Specification change of load side terminals for 800A ELCB

Earth Leakage Circuit Breakers	NV800-SEW/HEW
--------------------------------	---------------

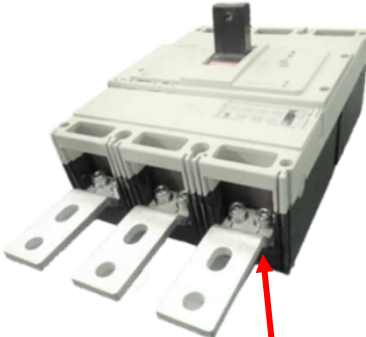
To change material and plating of load side terminals (left and right poles).

Before	After
<p>Ex.) NV800-SEW 3P Front connection type</p>  <p>Load side terminals</p> <p><u>With busbar terminal</u></p>	<p>Load side terminals (left and right poles)</p>  <p>Material: Copper Plating: Silver</p> <p><u>Without busbar terminal</u></p>	 <p>Material: Aluminum Plating: Tin</p> <p><u>Without busbar terminal</u></p>
